PJM Manual 15:

Cost Development Guidelines

Revision: [1718](#)

Effective Date: [June 1, 2014](#)

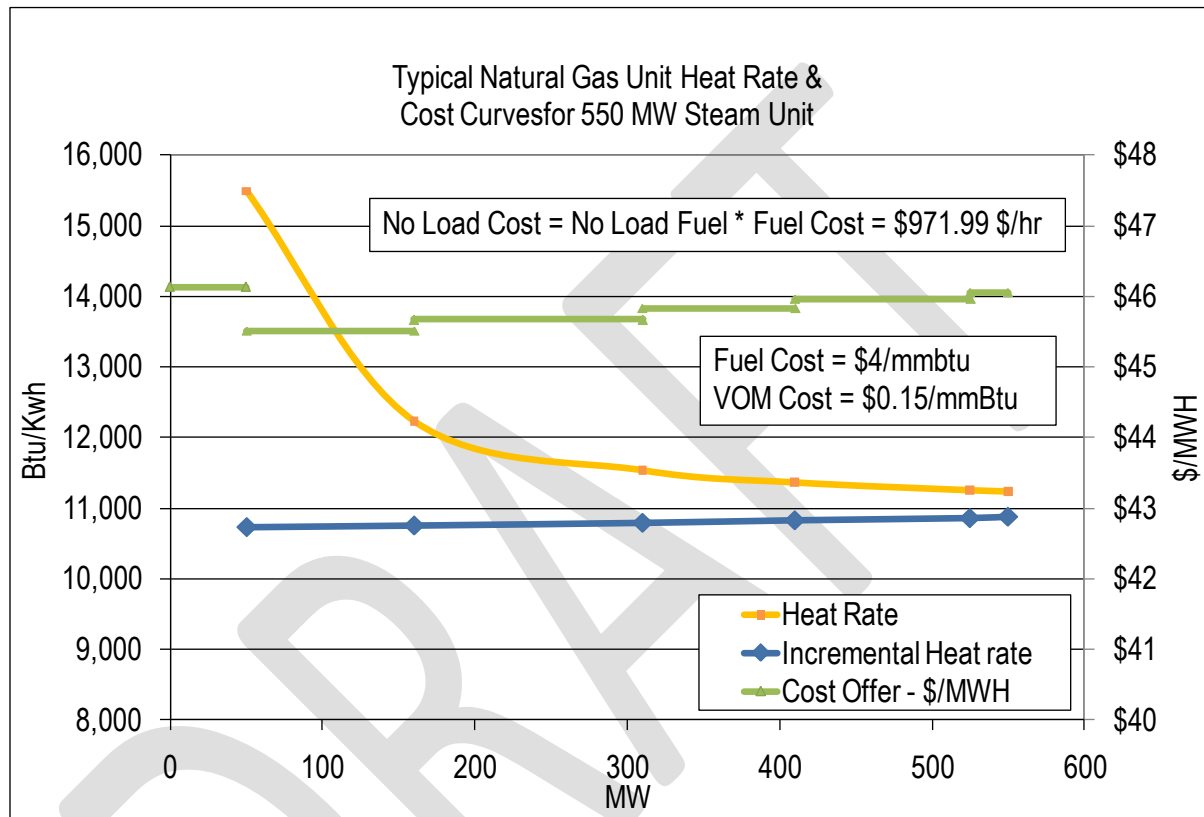
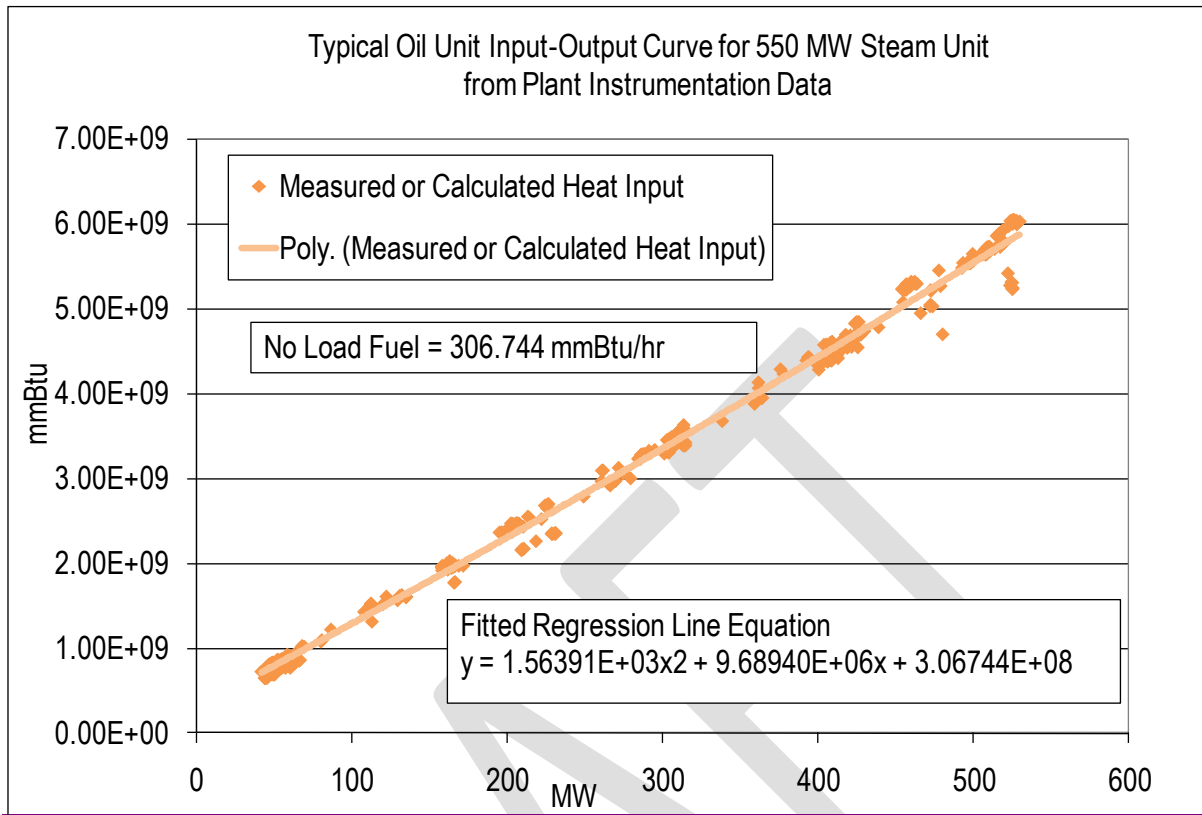
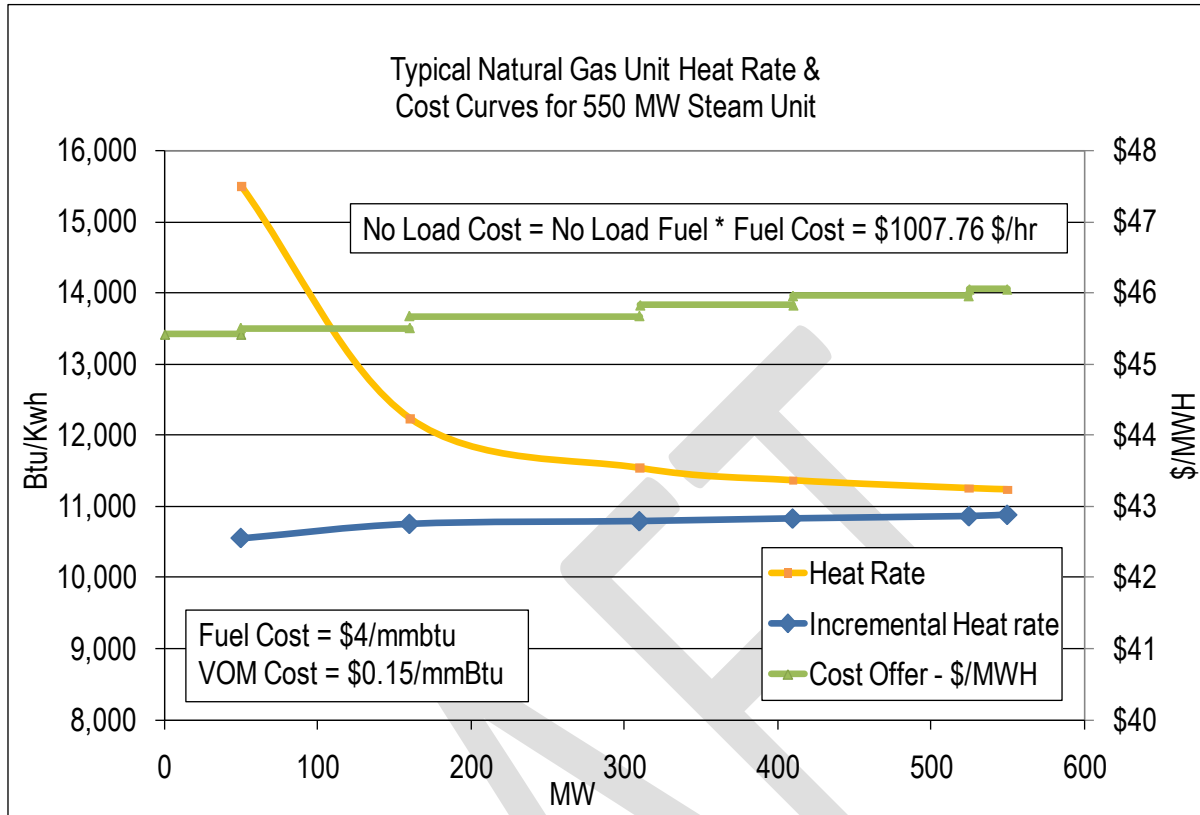
Once the No-Load Cost was calculated, the unit's cost curve was then developed. However due to the quality of the heat input data, the first increment of the cost offer was greater than the second increment. This is shown in the graph below:

The No-Load cost was then raised to \$1007.76 until the first increment of the cost offer was less than \$1/MWh or equal to below the second increment, producing a monotonically increasing curve in the graph below:-
